**LEGAL ADVERTISEMENT
HISTORIC PRESERVATION BOARD
CITY OF PORTLAND
Public comments are taken at all meetings.**

HISTORIC PRESERVATION BOARD AGENDA

**PUBLIC HEARING
PORTLAND CITY HALL PLAZA**

In response to Board comments at the June 7 workshop, the project architects have made a number of revisions to their initial proposal. The revisions are summarized in a cover memo included as Attachment 1. The consultants will be bringing material samples to the meeting. Staff has asked that more detailed wall sections, specifications and final site plan be provided as well.

SCHEMATIC SITE & LANDSCAPE PLAN
BUKOWSKI RESIDENCE
55 BOWDOIN STREET
PORTLAND, ME

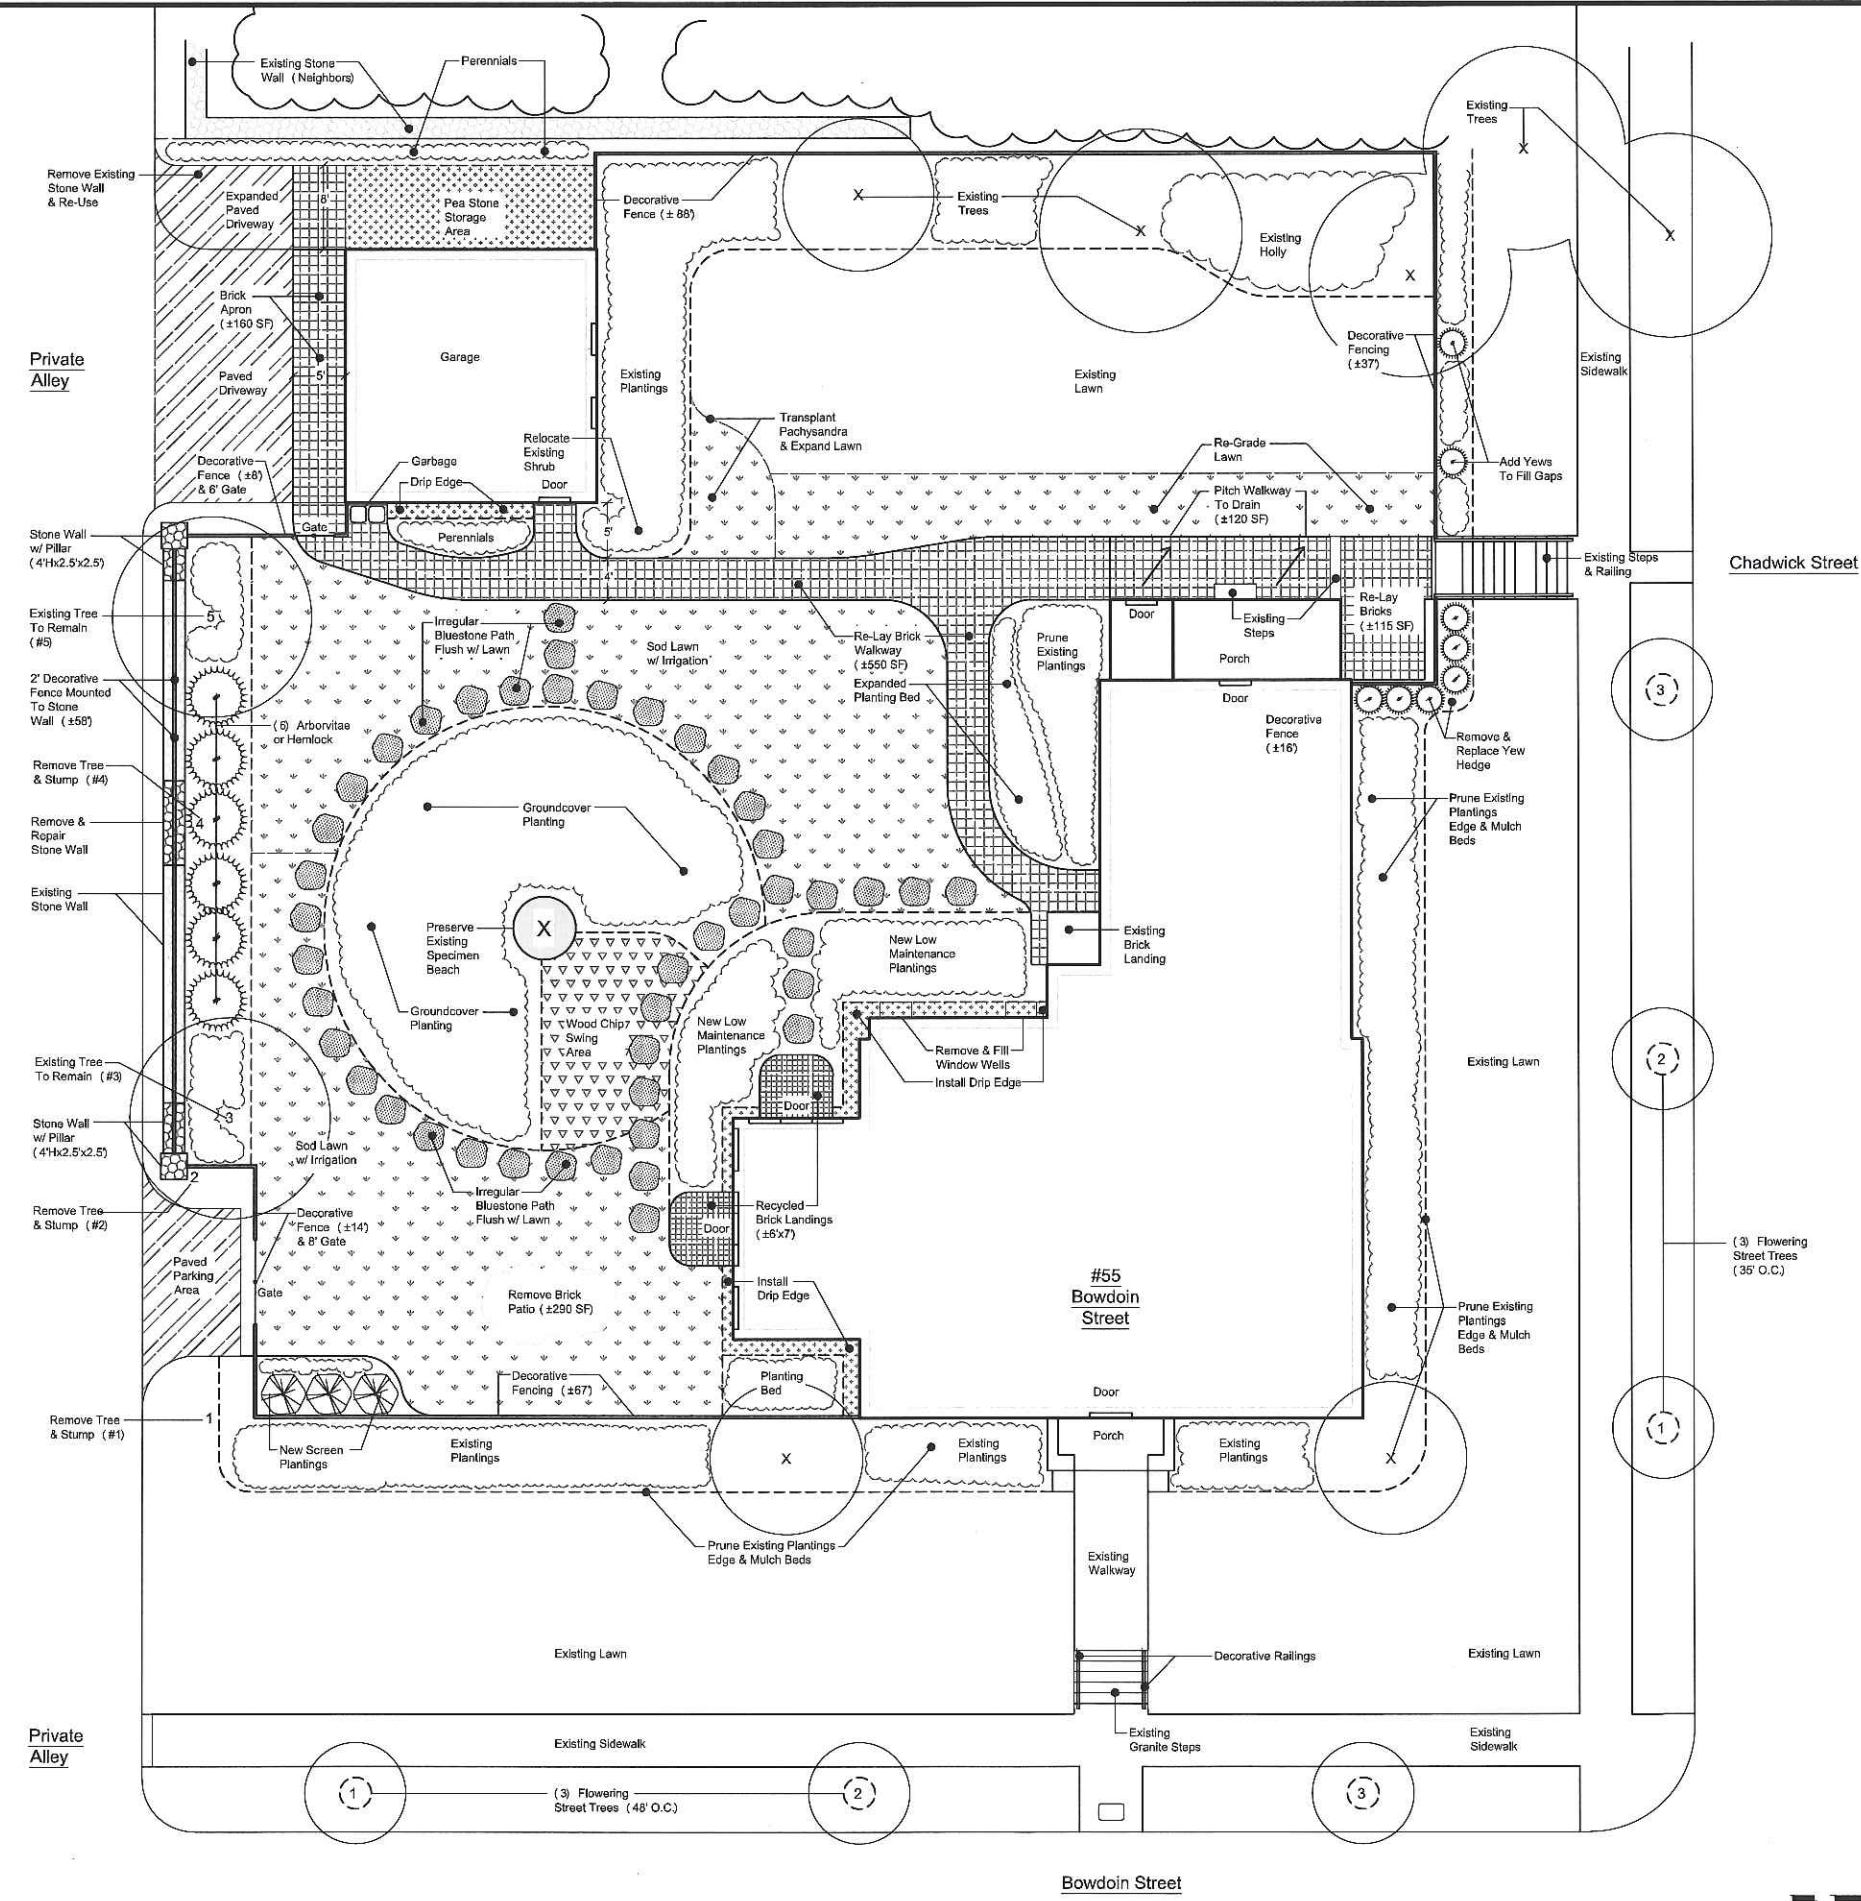
Staff has also shared with the applicant some concerns about formalizing the informal parking space located closer to the property's Bowdoin Street frontage. This appears to be unnecessary given the amount of parking in and around the garage. With respect to the proposed additional parking space next to the garage, staff feels it will have minimal impact on the character of the property, especially given the proposal to introduce additional plantings alongside it at the property line.

Finally, staff notes that no drawing has been provided for the railings proposed for the granite steps near the Bowdoin Street sidewalk. While the applicant has described what they have in mind, staff suggests that the Board include as a condition of approval the requirement that the final railing detail be reviewed and approved by staff.

FRONT ENTRY PLAN
 SCALE: 1/2" = 1'-0"
 (EXISTING CONDITIONS)

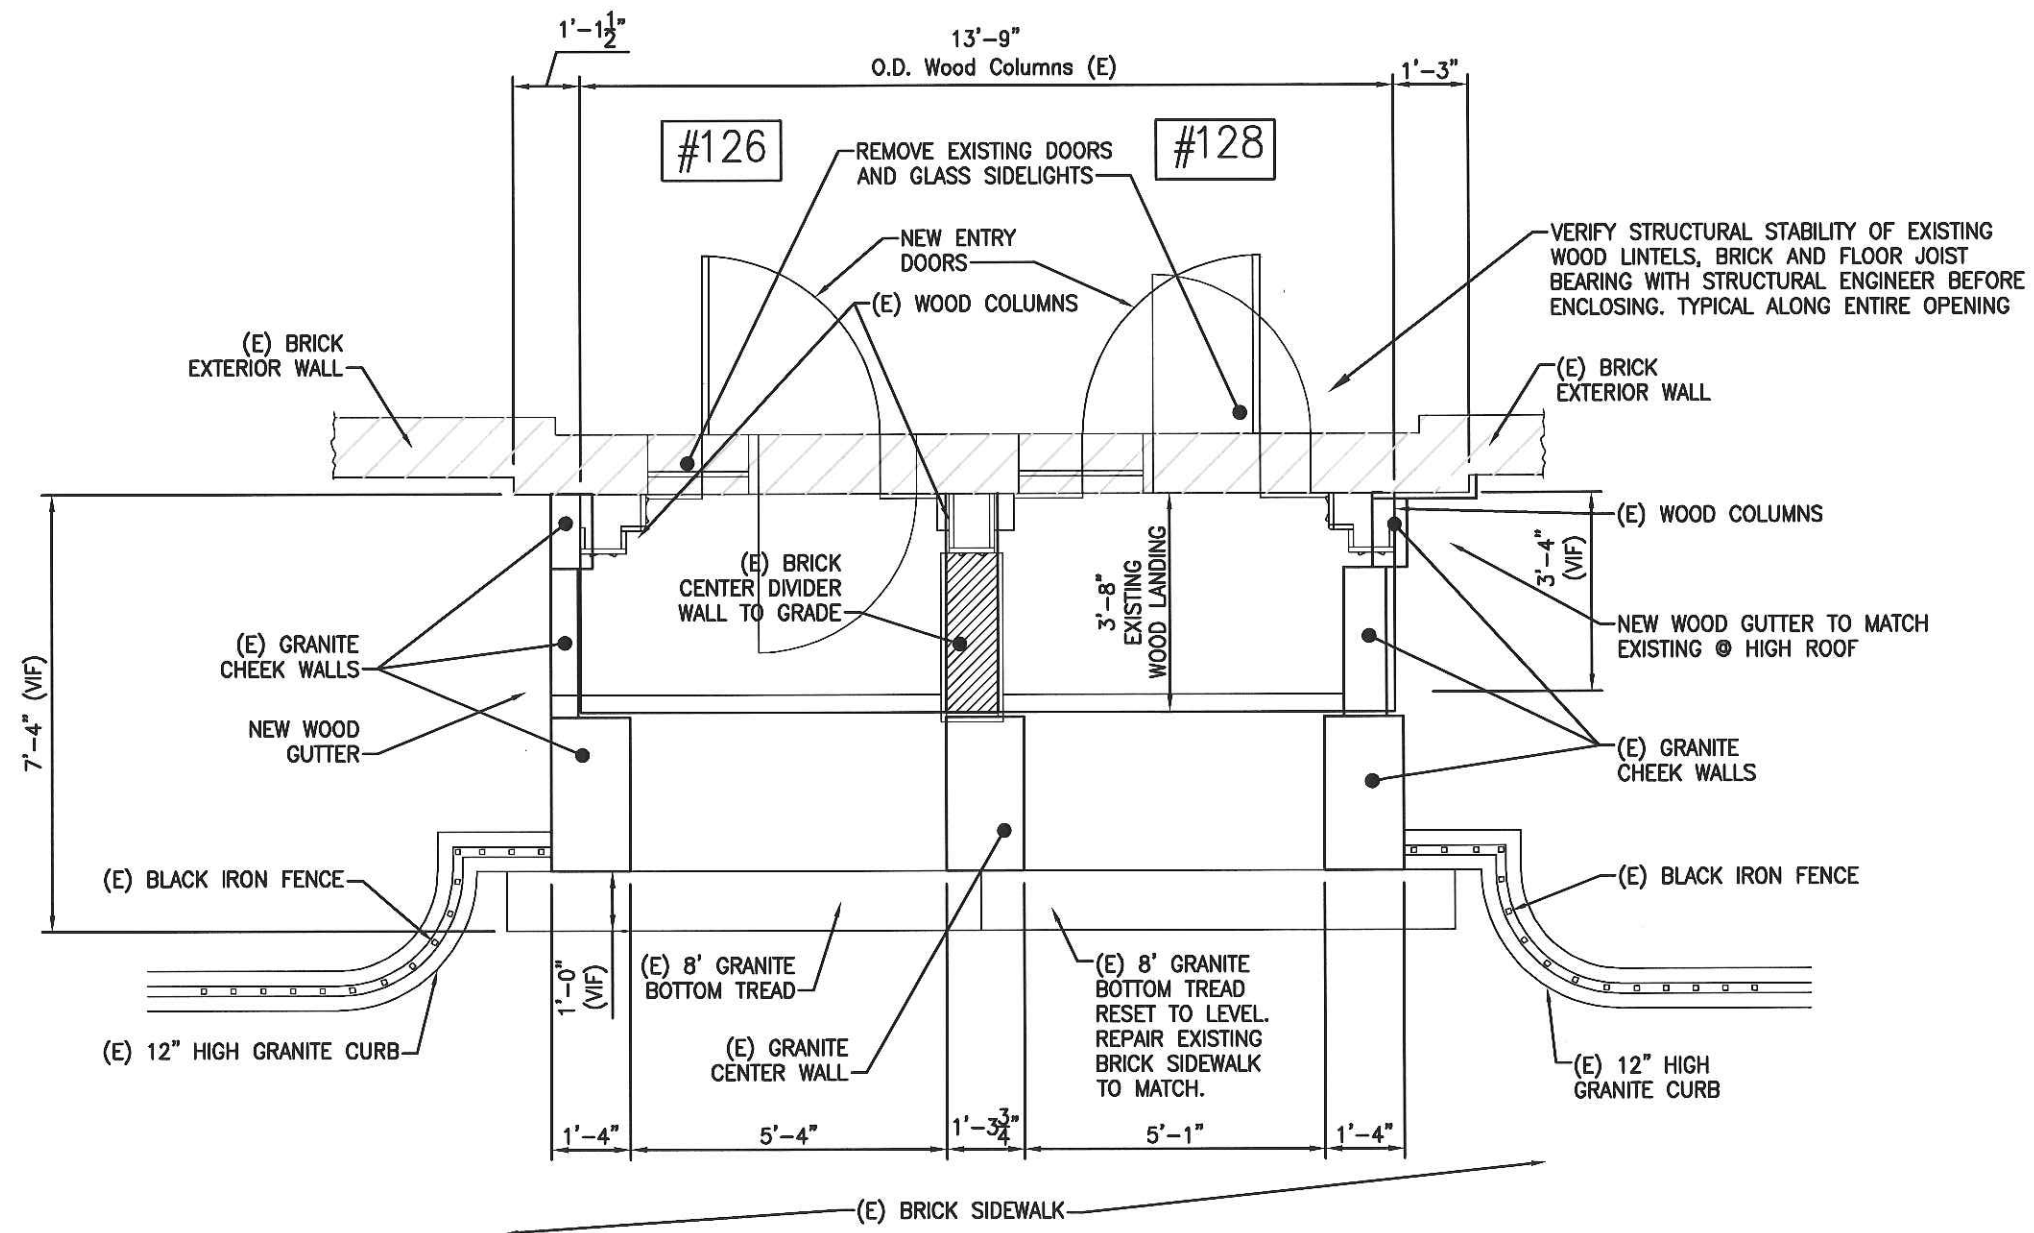
- Given the existing granite cheek walls, fence base, and bottom step, new granite for the stairs, cheek walls, and landing seems a reasonable and durable choice. The original stair material is uncertain; whether granite or some other masonry material preceded the wood and was removed for some reason is unknown. An existing conditions plan and email from the architect indicate that the current porch is on wood framing supported by a brick wall in the center and vertical granite slabs of varying dimensions on the sides.

- Wood stairs between granite walls are not common as an original entrance design. It is hard to imagine why original granite stairs might have been removed and replaced by wood. Perhaps the original stairs were wood and at some later date granite cheek walls were added to the sides. In any event, staff does not disagree with the choice of granite.

- In reconstruction of the hood Mr. Leasure proposes to widen (or deepen) the hood slightly to restore symmetry to the paneled canopy ceiling. Examining the existing condition of the hood, it seems plausible that repairs of rotten fascia, gutter and cornice on the front of it resulted in a loss of material and dimension.
- A light fixture is shown on page A5 of the plans. If the section of the canopy does not hide the fixture from the front, staff wonders if the fixture would be adequately shielded to avoid glare.
